CITY OF BERKLEY, MICHIGAN SPECIAL MEETING OF THE CITY PLANNING COMMISSION

To: Planning Commission
From: Kristen Kapelanski, Community Development Director
Subject: **PSP-15-22: 28557 Woodward – Seven Point Provisioning Center**
Site Plan Approval
Date: September 9, 2022

Re: Seven Points Provisioning Center
28557 Woodward Avenue
Engineering Site Plan – Review No. 2
City of Berkley, MI

Site Plan Review
For
City of Berkley, Michigan

STORM WATER MANAGEMENT PLAN

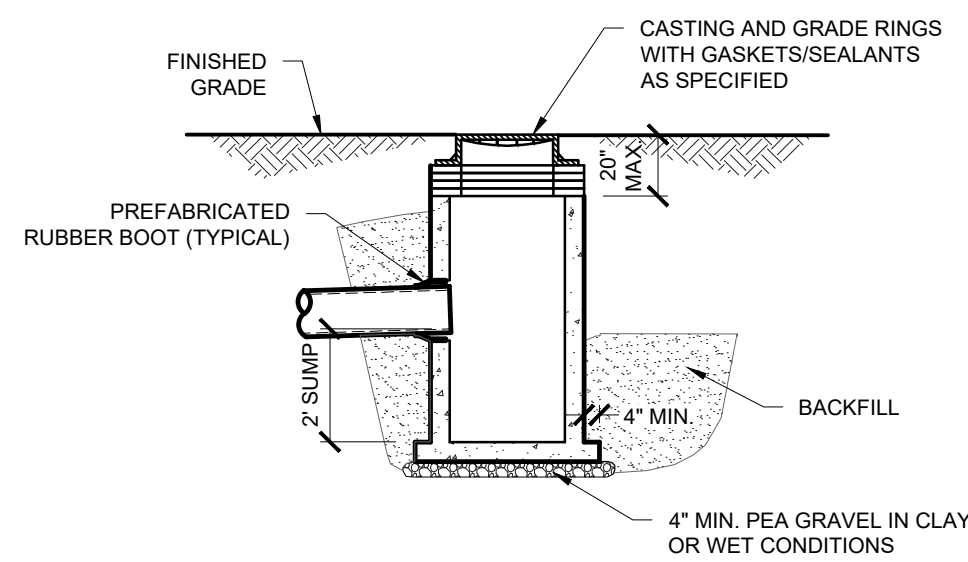
2. The stormwater calculations show that 1,925 cubic feet of storage is required, however, the StormTech Chamber System Details show the system to only provide 1,104 cubic feet of storage, including the stone. Storage must be provided on the proposed site to account for the full value required by Oakland County standards. The required storage volume must be revised as per the previous comment as well to include the full site area. **The chamber storage volumes have been increased and the two chambers will provide adequate storage to detain the stormwater on site, however, the stormwater collected from the building area of the site does not reach the chambers to be detained and is instead proposed to flow into the rain garden and directly into the restricted outlet into the City sewer. To properly utilize the storage and meet the County requirements, the stormwater collected from the roof should be directed into the proposed underground system where it can be detained.**

5. Note that downspouts are not permitted to discharge directly into the combined sewer system and must be directed onto grass, landscape or other green space area. They may also be directed through the proposed stormwater detention system and restricted-outlet structure. The location of the proposed downspouts and the above note must be shown on the plans. **The downspouts have been shown on the plans and will be directed into the rain garden. As stated above, however, these should be directed into the underground storage below the parking lot.**

Based on our aforementioned comments, we recommend approval of the proposed Site Plan subject to the applicant revising the stormwater connection from the downspouts, and obtaining and submitting copies of any required permits as well as the stormwater maintenance agreement.

LANDSCAPE PLAN

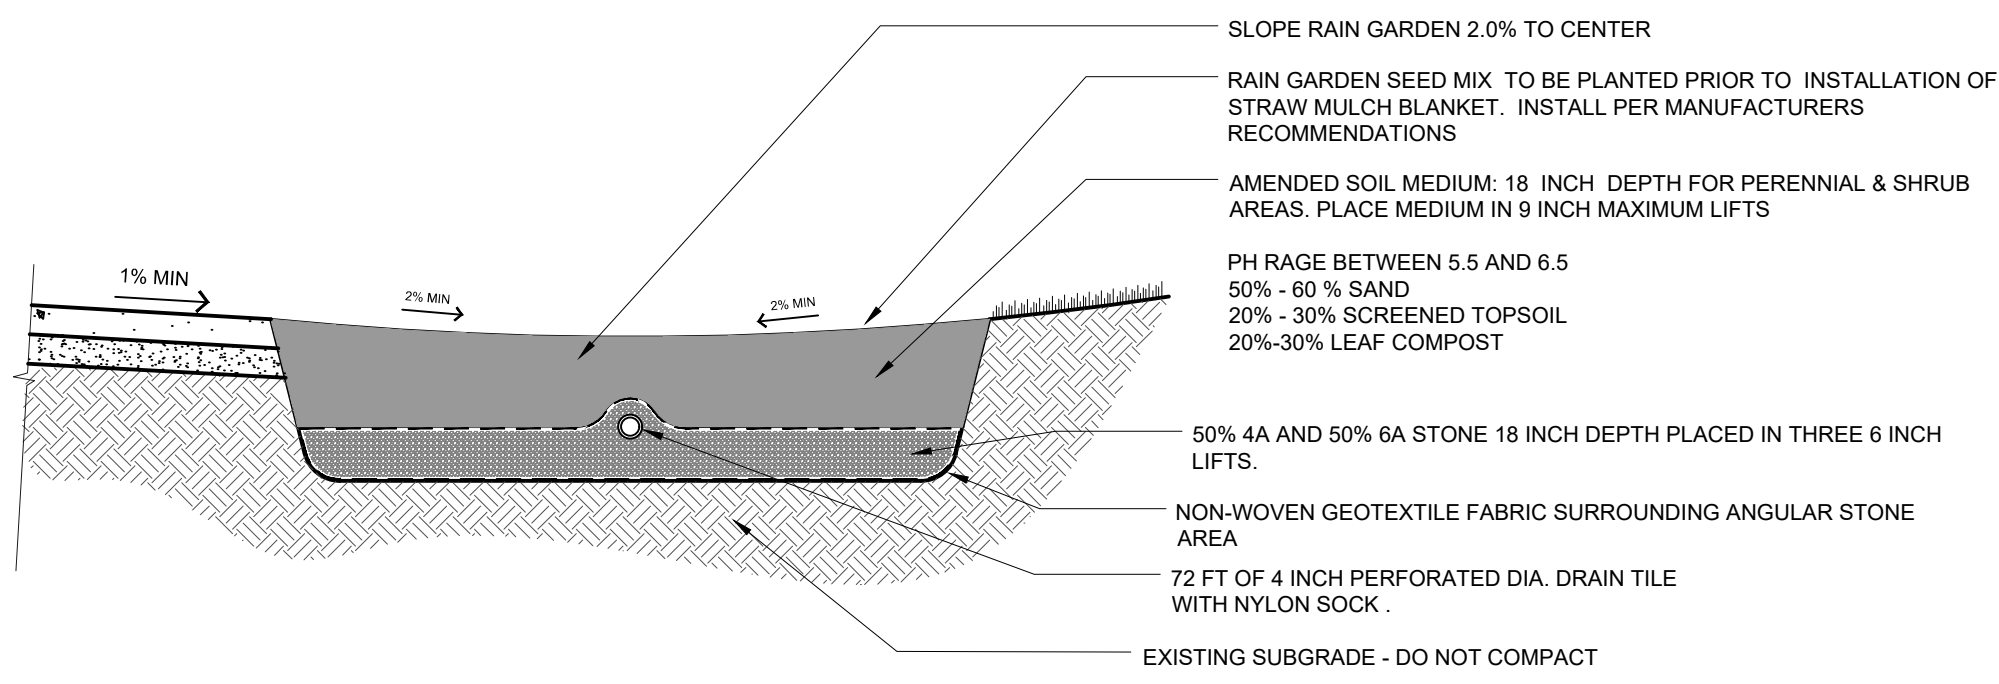
A landscaping plan has been provided on sheet L101. The applicant proposes robust landscaping improvements including:

- Green roof
- Parking lot landscaping
- Street trees
- Planter boxes along Woodward
- Rain garden along Wiltshire

As set forth in Section 130-37, when the development of any property requiring site plan approval occurs, the City Planning Commission shall review landscaping plans and may require additional landscaping to be planted on or near the site consistent with the elements of the adopted city master plan.

Items to be Addressed: *Planning Commission to review landscaping*
